TO: All Design Section Staff  
FROM: Bijan Khaleghi  
DATE: January 28, 2021  
SUBJECT: Abutments Supported By Mechanically-Stabilized Earth Walls

This design memorandum provides revisions to the requirements for abutments supported by mechanically-stabilized earth walls. Bridge Design Manual Sections 7.5.2 and 15.7.5 shall have the following updates.

### 7.5.2 **Abutments Supported By Mechanically-Stabilized Earth Walls**

Figure 7.5.2-1

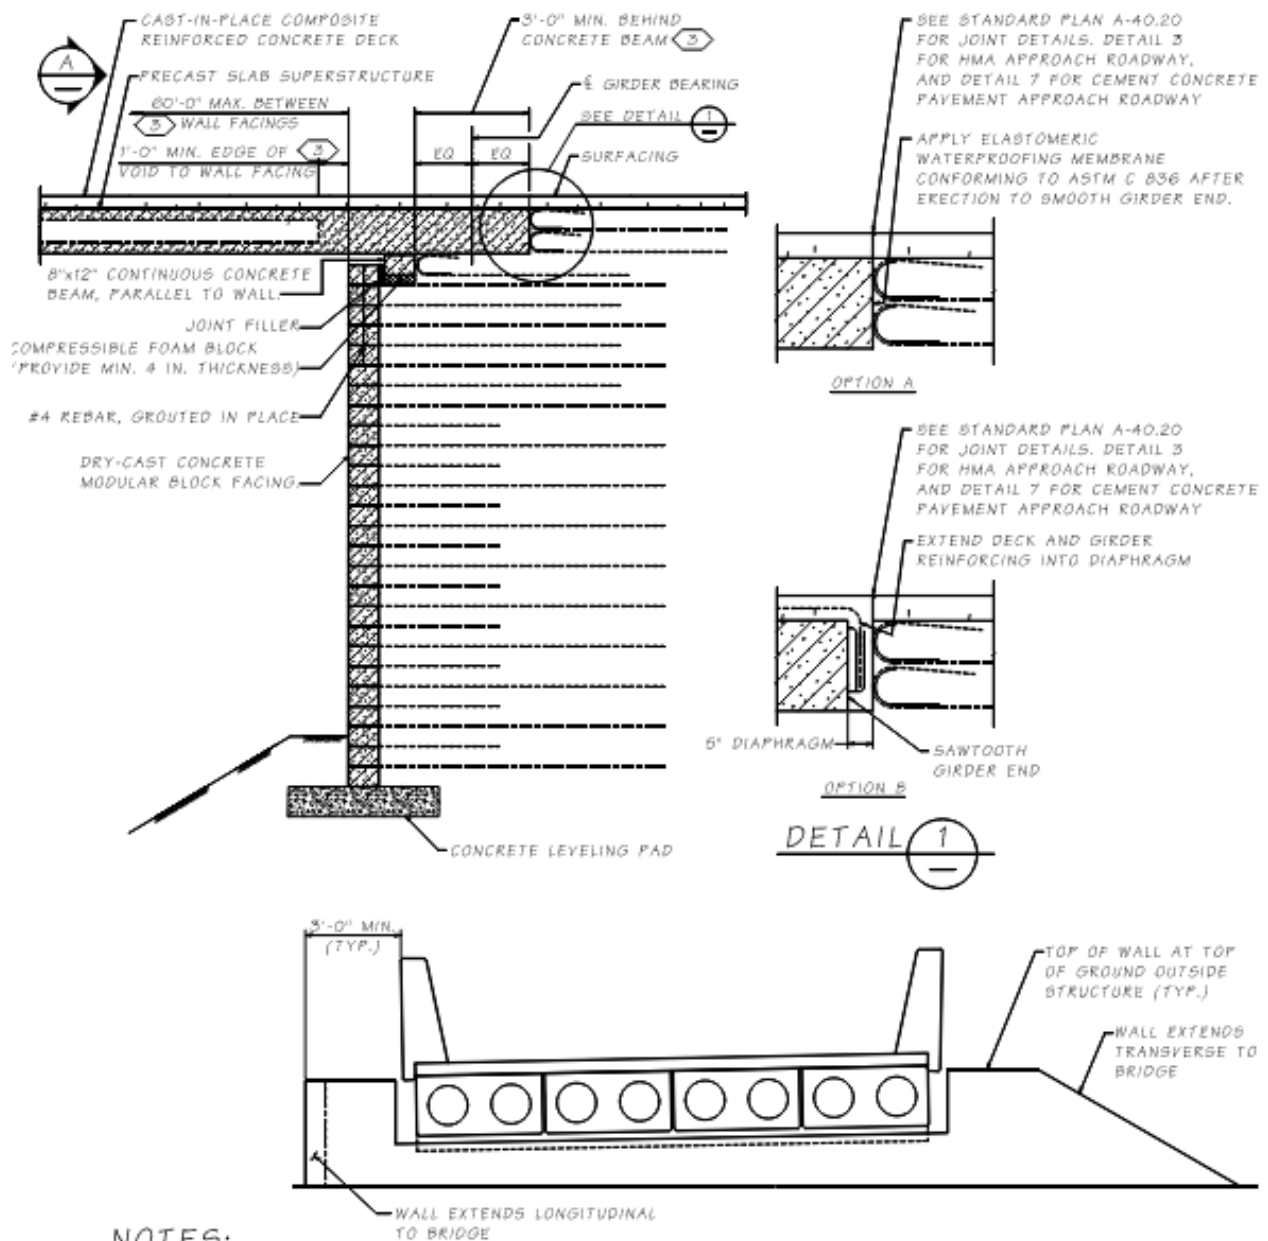
Figures 7.5.2-1 and 7.5.2-2 shall be replaced with the following Figures 7.5.2-1 and 7.5.2-2.

1. LATERAL RESTRAINT NOT SHOWN, BUT REQUIRED FOR DESIGN.
2. FALL PROTECTION NOT SHOWN FOR CLARITY.

(3) LONGITUDINAL DIMENSIONS ARE MEASURED NORMAL TO THE WALL

Figure 7.5.2-1 Reinforced Soil Abutment with Dry-Cast Modular Block Facing

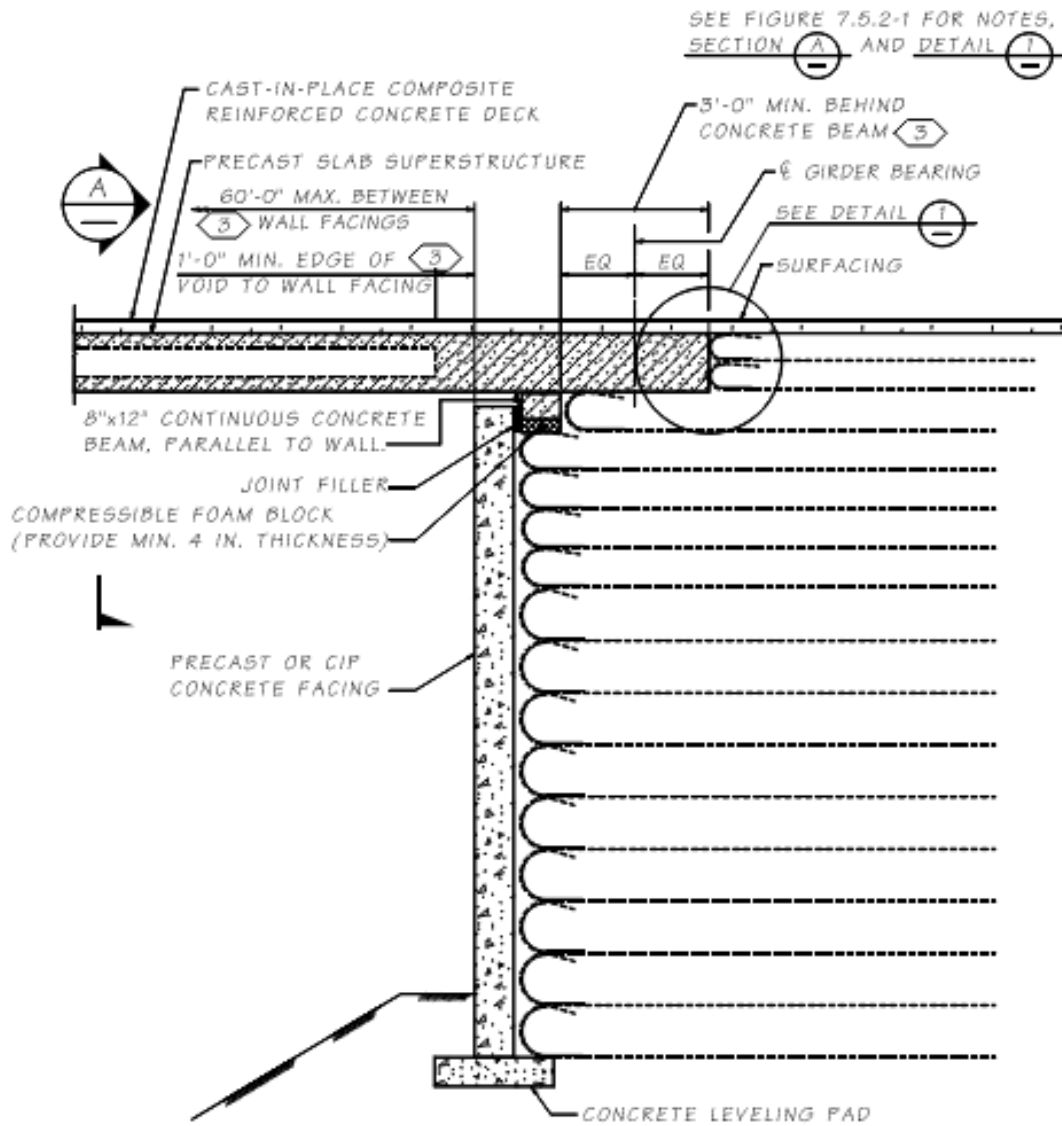
These bridges shall conform to the following requirements, see Figures 7.5.2-1 and 7.5.2-2:

1. Walls supporting abutments shall be special designed wall systems, and shall conform to GDM Section 15.5.3.6 MSE Wall Supported Abutments. Additionally, the top 3 rows of dry-cast modular concrete blocks shall be grouted with #4 rebar.

2. The ~~span~~ superstructure length shall not exceed 60 feet between wall facings, and the bearing location shall be taken as the midpoint between the concrete beam and the girder end.

3. The superstructure shall include a 5" **minimum** thick C.I.P. composite topping.
4. The end of the precast superstructure shall be at least 4 feet from the back face of the MSE wall. Minimum seat width requirements shall be provided on the reinforced soil bearing area.

5. A foam board detail shall be used to create a 1 foot horizontal buffer between the bearing area and the wall facing.
6. The vertical gap between the top of wall facing and the bottom of superstructure shall be 4" or 2 percent of the abutment height, whichever is greater.

7. Prestressing strands in the zone bearing on reinforced soil shall have a minimum concrete cover of 2". Transverse reinforcing steel within this zone shall have a minimum concrete cover of 1½". All prestressing strand shall be removed to a 2" depth from the end of the slab. The voids shall be patched with epoxy grout.

**Figure 7.5.2-3** Spread Footing on SE Wall or Geosynthetic Wall

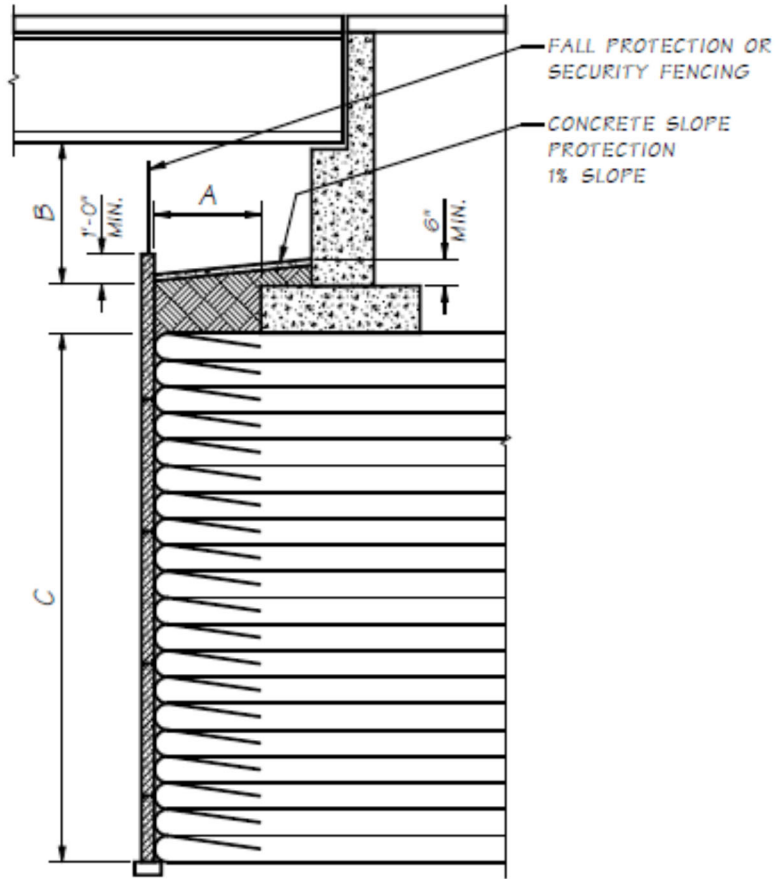
These bridges shall conform to the following requirements, see Figure 7.5.2-3:

1. Walls shall be 30 feet or less in total height, which includes the retained soil height up to the bottom of the embedded spread footing.

2. For SE walls, the front edge of the bridge footing shall be placed 4 feet minimum from the back face of the fascia panel. For geosynthetic retaining walls with a wrapped face, the front edge of the bridge footing shall be placed 2 feet minimum from the back face of the fascia panel.

- A. 4'-0" MIN. FOR SE WALLS (PRECAST CONCRETE PANEL FACE OR CAST-IN-PLACE CONCRETE FACE) AND 2'-0" MIN. FOR SPECIAL DESIGNED GEOSYNTHETIC RETAINING WALLS WITH WRAPPED FACE.
- B. 3'-0" MIN. FOR GIRDER BRIDGES AND 5'-0" MIN. FOR NON-GIRDER, SLAB, AND BOX GIRDER BRIDGES. (SEE SECTION 7.5.3)
- C. 30'-0" MAXIMUM (SEE SECTION 7.5.2B.1)
